CENTERVILLE CITY PLANNING COMMISSION AGENDA

**Staff Backup Report
9/12/2018**

LEGACY COMMONS -FINAL SITE PLAN SUBMITTAL FOR MULTI-FAMILY DEVELOPMENT - *(Final Site Plan Submittal Compliance Assessment by Planning Staff)*

Figure 1 The red line shows roughly where the new fence will be placed on the property

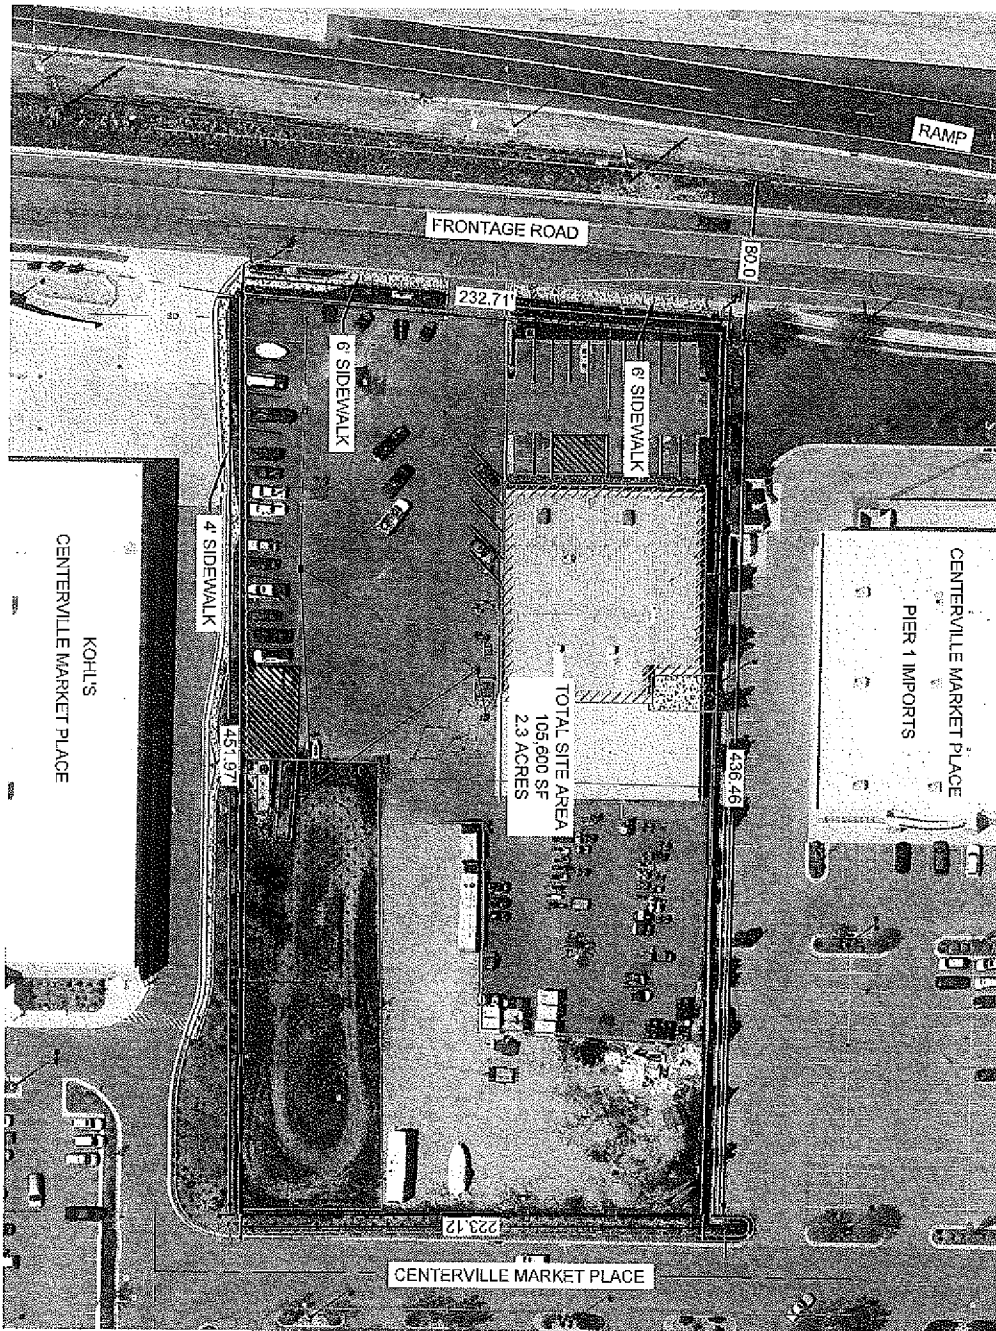
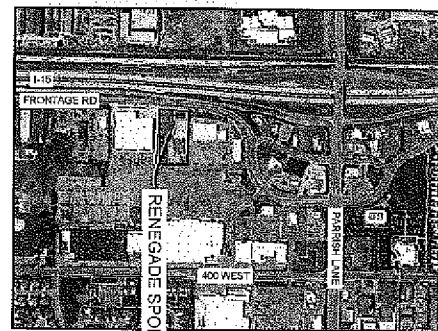
The surrounding properties around the fence are facing parking lots and drive aisles. No buildings immediately abut the proposed fence area. The opaque screening fence is to visually shield the storage of vehicles and equipment of Renegade Sports. Due to the slope of the property on the property lines, the fence will need this added height in order to screen adequately while maintaining adequate aesthetics for the area.

I hereby make a motion for the Planning Commission to approve the increased height of the fence for Renegade Rentals at 240 Frontage Road, which shall not exceed a maximum height of 10 feet.

LANDSCAPE PLAN

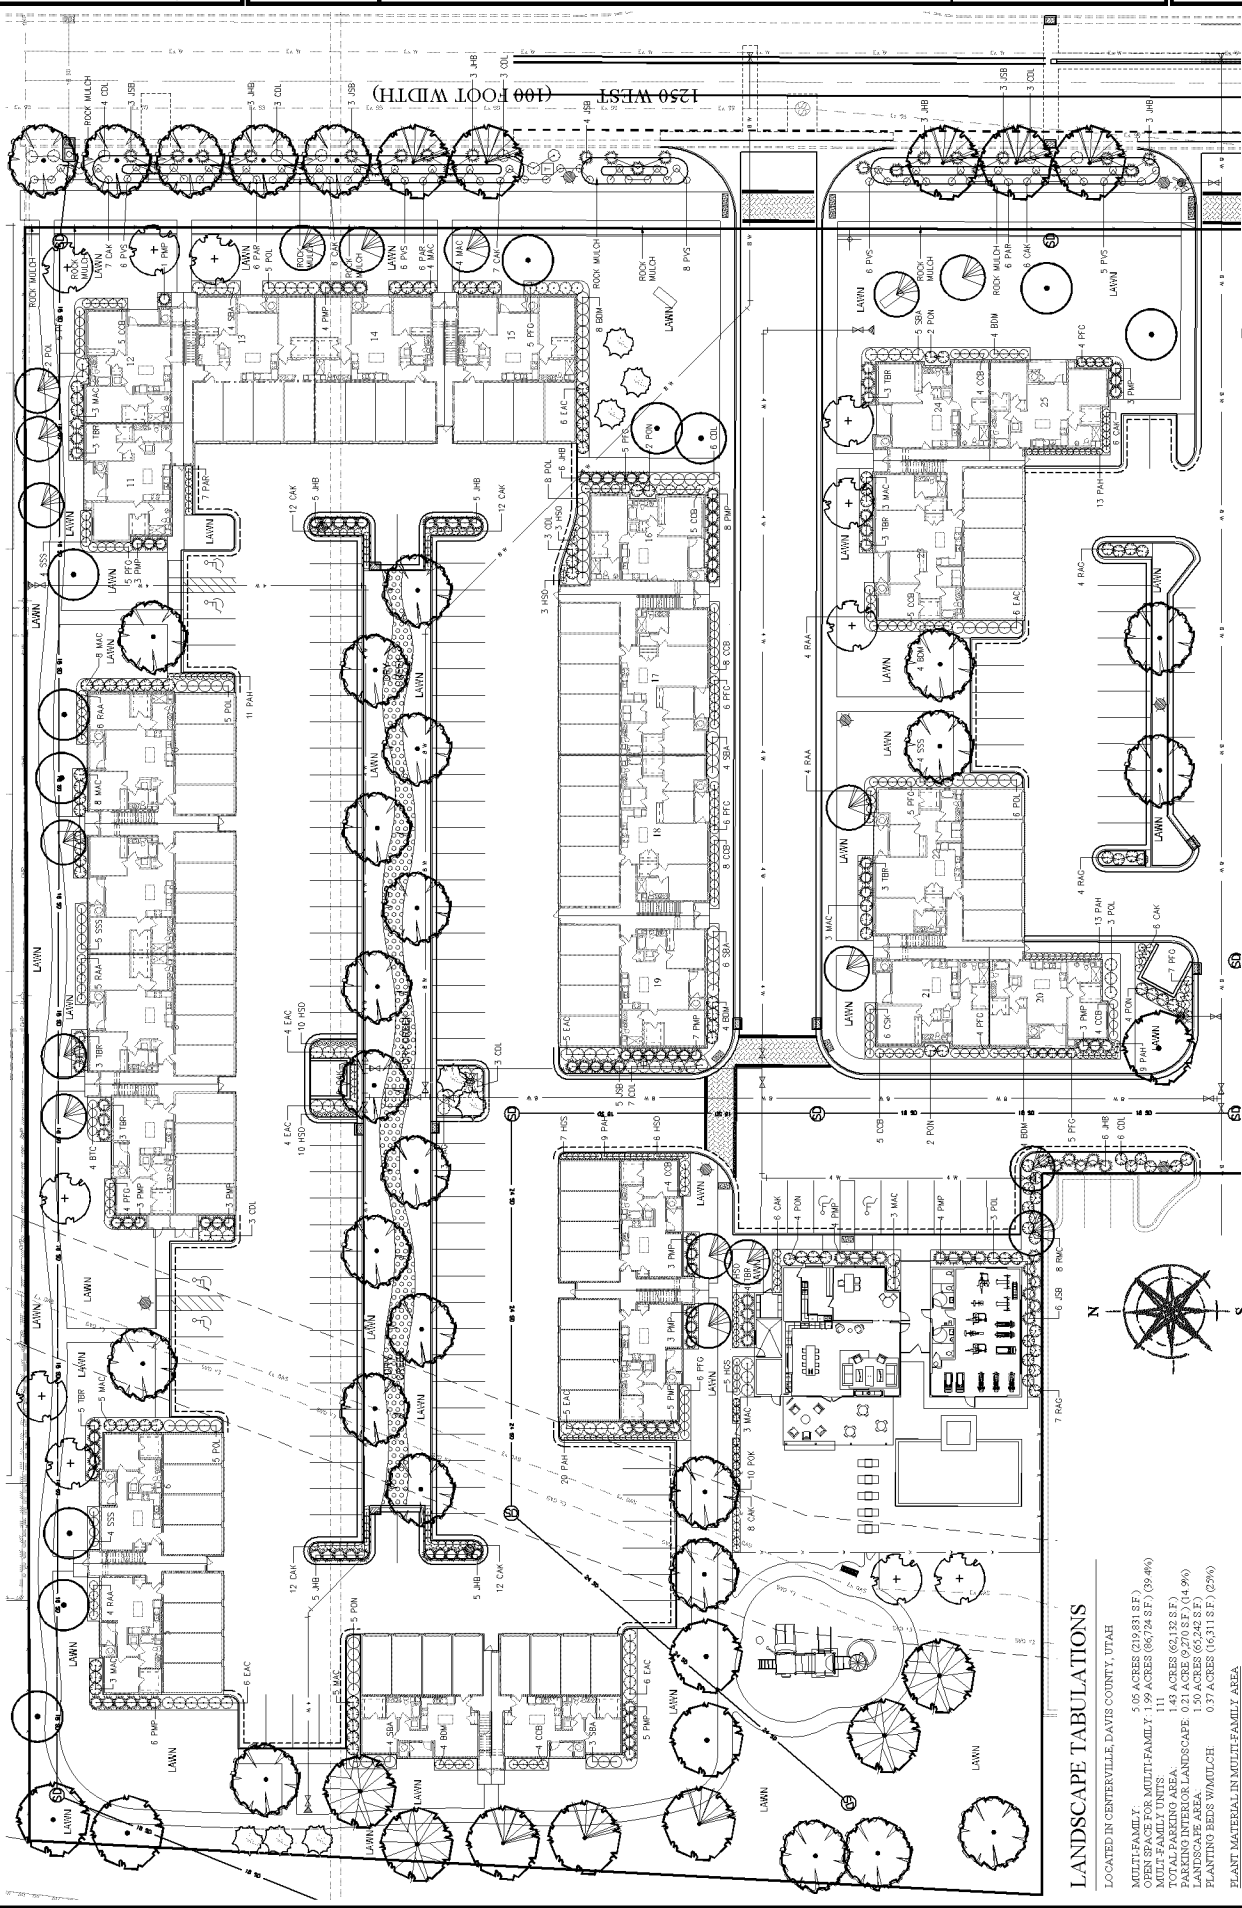
Staff Comments: The Phasing Plan does address the temporary landscape treatments for dust and weed control for areas not being developed. The landscaping plan does NOT address the less than 75% planting being turf or high water needing plants. All other expected design elements appear to be in compliance

Staff Comments: Staff perceives that the parking lot contains 10% landscaping. However, the landscape or site plan needs to provide the calculation in the tabulation tables. All other expected design elements appear to be in compliance

Staff Comments: The applicable PDO approval required only 31% landscaping. However, there is 39.3% open space total when counting the common space amenities. The staff count for one tree/2 shrubs per unit with the allowed substitute of 25% is depicted on the landscape plan. All other expected design elements appear to be in compliance
